PROJECT: Williamson County Sheriff's Office Training Center

PR 024 Owner Changes

PROPOSAL REQUEST

BRINKLEY SARGENT WIGINTON ARCHITECTS OWNER ARCHITECT CONSULTANT CONTRACTOR Distribution: \boxtimes \boxtimes **FIELD** OTHER PROJECT: Williamson County Sheriff's Office Training Center PROPOSAL REQUEST NO: 24 8160 Chandler Road **Hutto, TX 78634** OWNER: Williamson County 3151 SE Inner Loop Georgetown, Texas 78626 American Constructors, Inc. TO: **INITIATION DATE:** 1/25/2018 11900 West Parmer Lane Cedar Park, TX 78613 PROJECT NO .: 21522.00 **CONTRACT FOR:** General Construction **CONTRACT DATE:** 12/20/16 Please submit an itemized quotation for changes in the Contract Sum and/or Time incidental to proposed modifications to the Contract Documents described herein. Description: Owner changes to project scope Item No. 1. **DELETE WIRE CAGES** A. A212 – FLOOR PLAN – EQUIPMENT, INTERIOR ELEVATIONS, & SECTIONS; Room 143 Defense Tactics B. A800 - FINISH SCHEDULE & EQUIPMENT SCHEDULE, NOTES & LEGENDS: Delete (2) EQ-187 Item No. 2. DELETE PEG BOARD A. A212 - FLOOR PLAN - EQUIPMENT, INTERIOR ELEVATIONS, & SECTIONS: Room 141 Delete EQ-063-3 B. A904 - INTERIOR ELEVATIONS Item No. 3. ADD (1) O

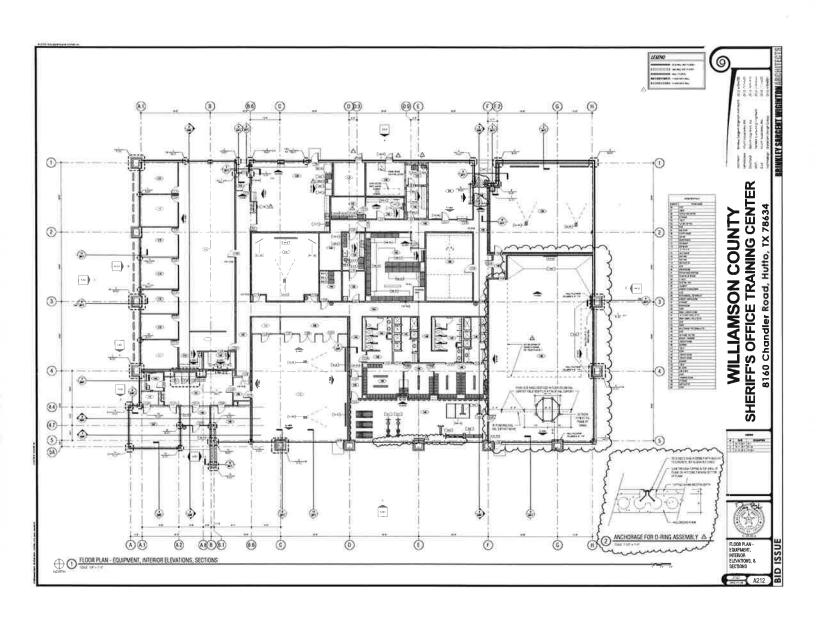
Item No. 11. ADD & DELETE WALL PADS

- A. A811 FINISH PLAN; Room 143 D.T.; Delete wall pads on West wall, South wall, and partial East wall.
- B. A904 INTERIOR ELEVATIONS; Add 6' ht. wall pads on North wall and West & East side wall of Alcove formerly Rooms 141 & 142; (keep wall pads below first set of windows and 2nd pilaster)

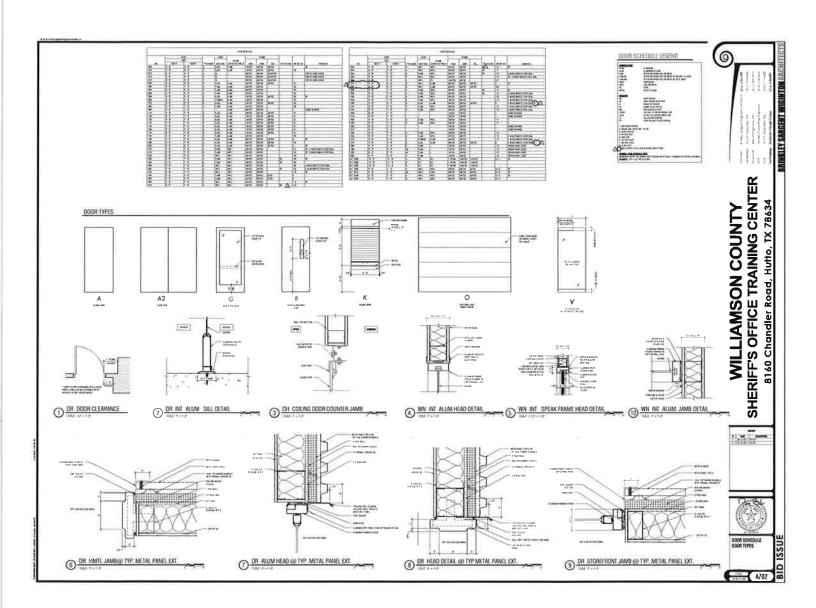
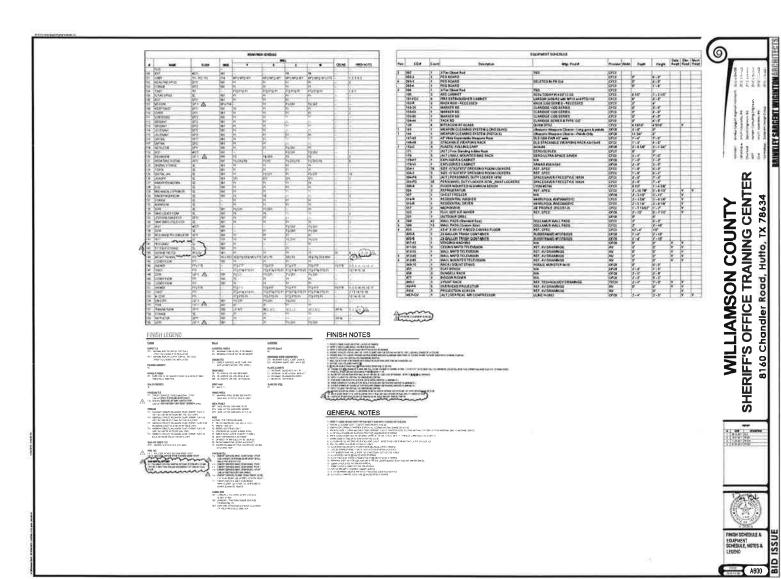
Item No. 12. ADD ELECTRICAL STRIP

- A. A903 INTERIOR ELEVATIONS; Room 144 Weight Training; Add vertical electrical strip at cabinets.
- B. E311 FLOOR PLAN POWER; Rm 144; Relocate outlet above base cabinet as vertical electrical power strip for phone charging station; center in wall.
- C. Ref. Keyed Note 4.

(PLEASE NOTE THAT WE ARE EXCLUDING THE VERTICAL STRIPS IN Item#12 until RFI is answered.)
